SG15-TD282/WP3 STUDY GROUP 15

Source:	Rapporteur Q10/15	
Title:	Differences between Recommendation 1 (03/2018) and draft Corrigendum 1 to R (2023) (for consent)	· · · ·
Contact:	Jessy Rouyer Nokia USA	Tel: +1 972 571 6521 Email: <u>jessy.rouyer@nokia.com</u>

Abstract: This PDF document shows the differences between Recommendation ITU-T G.8013/Y.1731 (2015) Cor. 1 (03/2018) and draft Corrigendum 1 to Recommendation ITU-T G.8013/Y.1731 (2023) (for consent).

Figure 6.2-1 – Example of MEs associated with a point-to-point connection administrative domain shown in Figure 237-1 of [ITU-T G.8010]

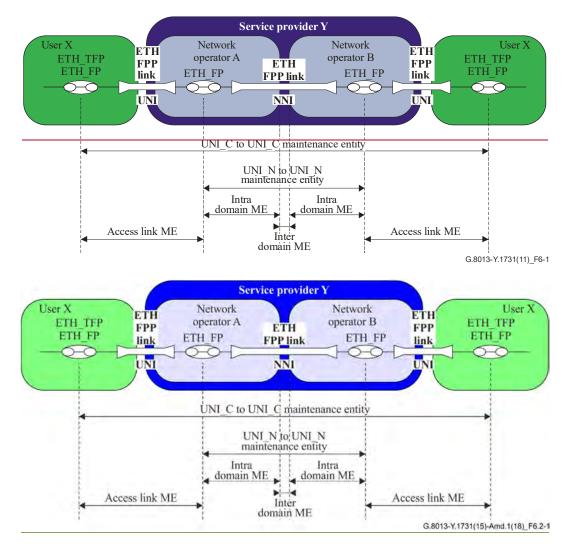
MEs in Ethernet networks are indicated in Figure 23<u>Figures 7-1</u> and Figure 24<u>7-2</u> of [ITU-T G.8010] and Ethernet MEs are defined in clause 9 of [ITU-T Y.1730]. MEs can nest but not overlap. Figure 6.2-1 illustrates an example of MEs associated with a point-to-point connection administrative domain.
